CITY OF PORTLAND, MAINE

Project Name:	The Cedars Expansion	Project ID:	2017-278, 2017-298
Address:	630 Ocean Avenue	CBL:	174-A-013
Applicant:	JHA Assisted Living, INC and Cedars Nursing Care, INC		
Planner:	Matthew Grooms

Planning Board Report Portland, Maine

630 Ocean Avenue, The Cedars Building Expansion
Level III Site Plan (2017-278), Site Location of Development and Conditional Use (2017-298)
JHA Assisted Living, INC and Cedars Nursing Care, INC, Applicant

Cedars Expansion Project - Tree & Landscape Comment Review

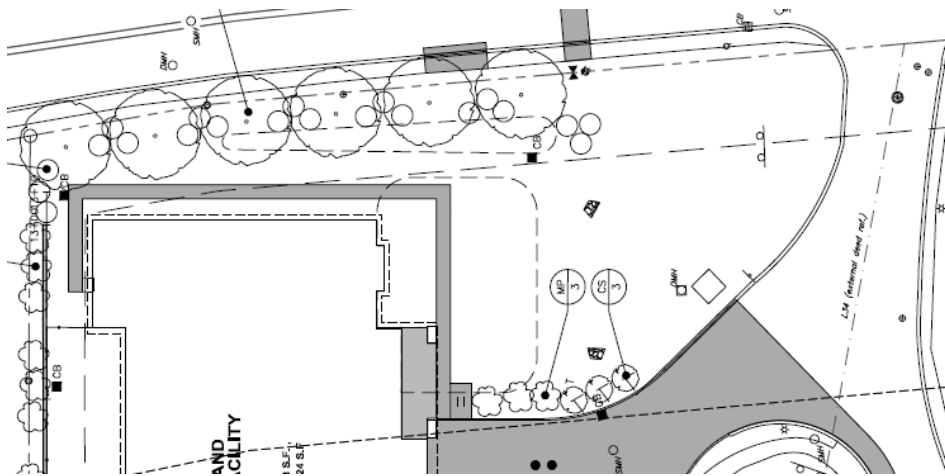
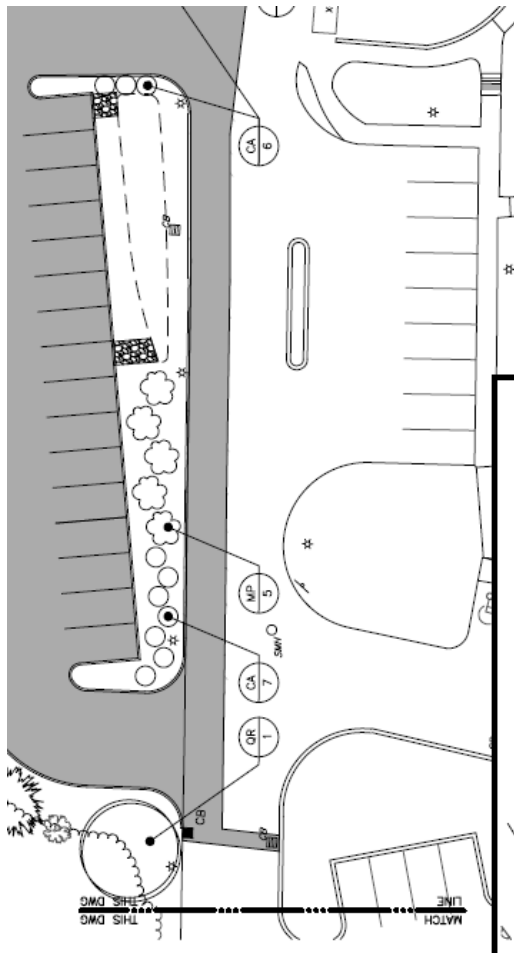
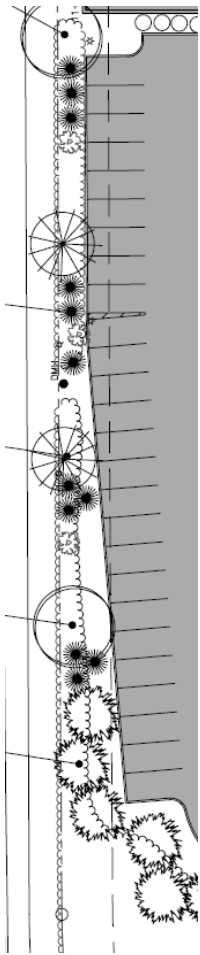
a) Street trees - the project proposes 6 'Karpick' Red Maple which is a good choice for this location and matches the existing trees planted west of the drive along Ocean Avenue.

b) Entrance-way landscape - how does the existing landscape blend into the new project. The final approval should show the details of the more formal ornamental landscape beds and limit of work.

c) Parking lot landscape - 'should meet parking lot landscape standards', The parking lot island appears to have a **stormwater feature** which is good, additional trees and shrubs could be used to meet parking lot standards. There appears to be room for a few trees, recommend Tupelo & or Red Maple 2" caliper size, (Tupelo is a slow growing native tree that tolerates wet conditions) and for shrubs Winterberry, Sweetern for examples. Ideally the island below would contain taller trees mentioned.

d) Rainbow Mall Road edge - The Rainbow Mall Road edge has been an important feature for the Cedar's since the original approval. The goal is to maintain a tree and vegetated edge that allows window views into to site for safety / security but maintains the wooded feel of the residential properties nearby.

From a quick review, it would be important to establish a limit of work and 'tree save' protection for the vegetation between the proposed project and Rainbow Mall, this should be a condition. The proposed tree and landscape treatment may need to be enhanced with additional trees and shrubs. A condition could be that if existing trees and vegetation is lost that additional plants be added. 'Tree Save' areas should be defined on site and part of the Pre-Construction meeting. This would included the usual requirements of not storing equipment or materials in or near the root zone of the tree save areas. Projection should include temporary construction fencing. The parking lot edge along Rainbow Mall Road could include low wooden guardrail along the edge to reduce vehicle encroachment into the buffer area. The Tree Protection web links below may be useful

e) Tree Planting Details - Revised tree planting specifications, The International Society of Arboriculture (ISA) have released improved tree and shrub planting details and spec sheets that no longer modify the sub-base beneath the planting in most situations. We would recommend that the Project revise the spec sheet in the Landscape Details to reflect these changes so the future landscape contractor installs the trees and plants correctly. We can supply with additional information, the web links below outline' these changes.

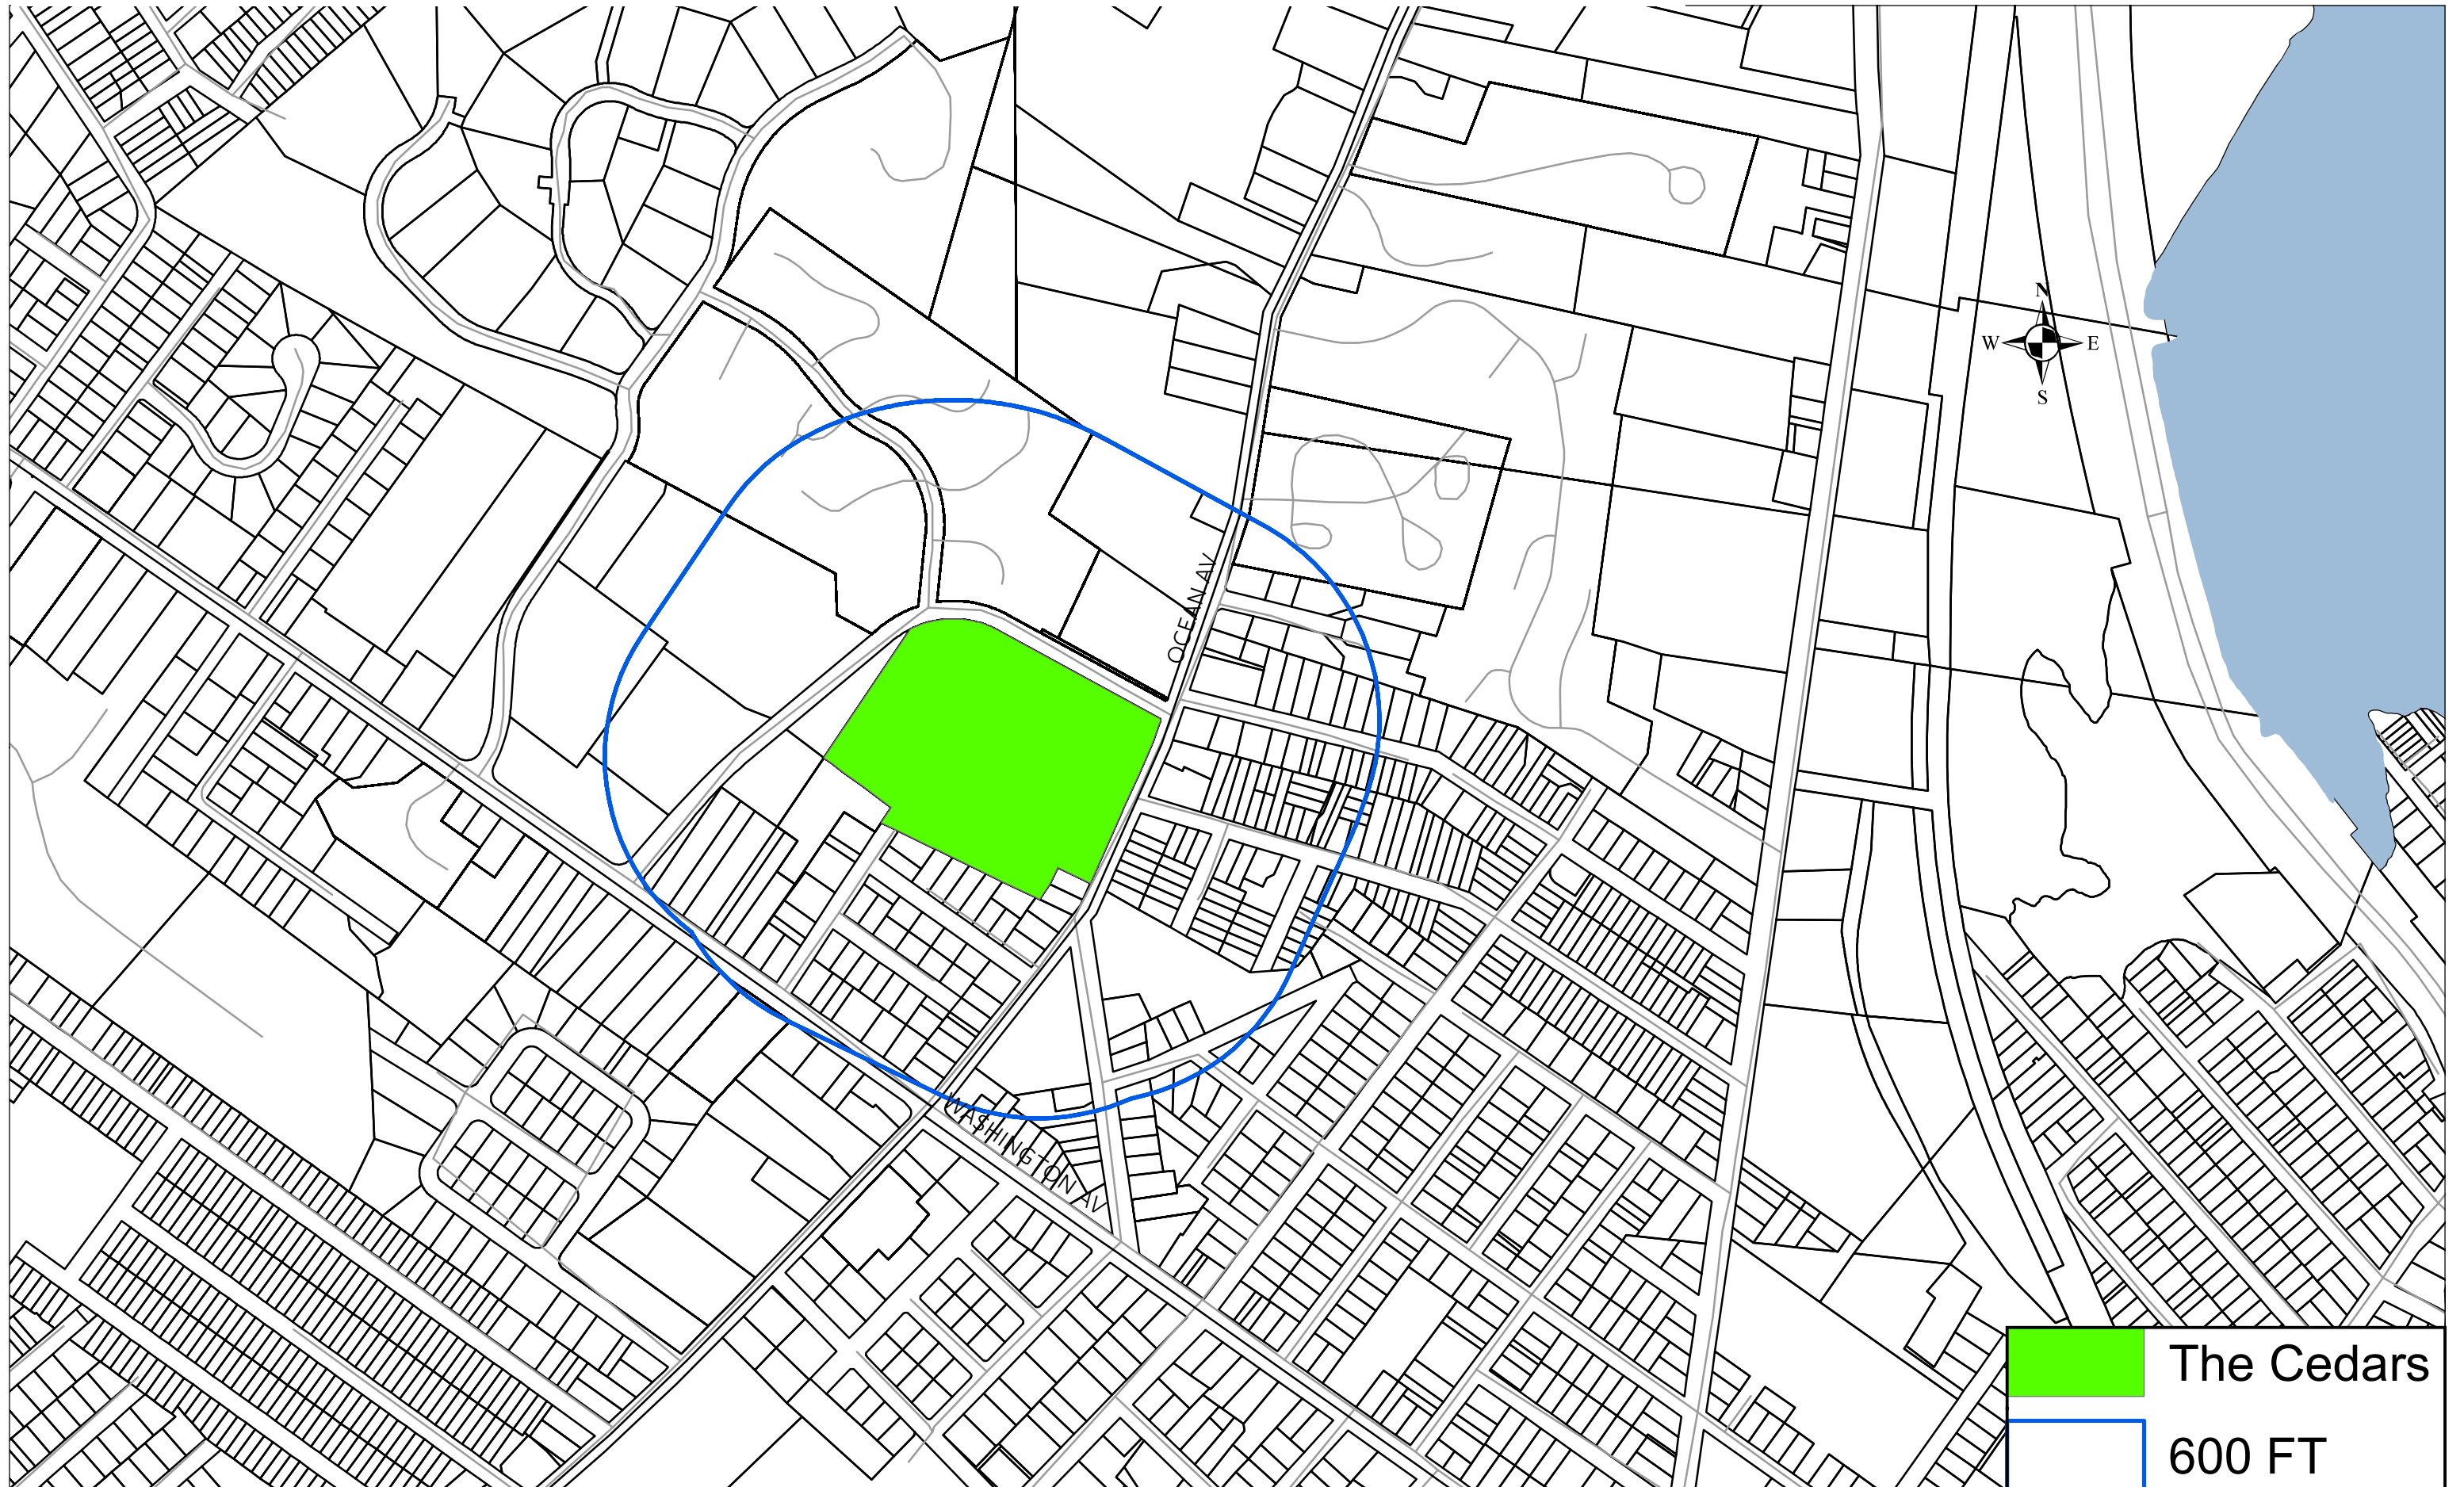
The document calls the proposed roof a “Gourmet Mansardic roof”. It is defined as “Structurally, a conventional flat-roofed building with an appended projecting element” as shown on the diagram. The roof itself is flat. This is also shown on the roof plan - plan A3.01, plan A5.01, and plan A5.02.

Although this document refers to it as a “mansard roof” based on the definition and plans, Zoning considers this a flat roof; therefore the height of the roof is measured to the highest point of the roof beam from the average grade. In the R-3 Residential Zone the maximum height is 35’ [section 14-90(g)].

The Adjacent Building Grades Plan by Wright Pierce, dated April 2018 (attached) shows the average grade for the building as 73.80 feet based on the proposed grade at the four corners of the building. On Plan A1.01 – Proposed Building Elevations revised 03.20.208 (attached) the Front Elevation shows the average grade line across the building at 73.80 feet. The “Top of Roof Deck/Truss Support beams” is shown as 35 feet above the average grade line. Based on these two plans, the building appears to meet the maximum height requirement of 35 feet.
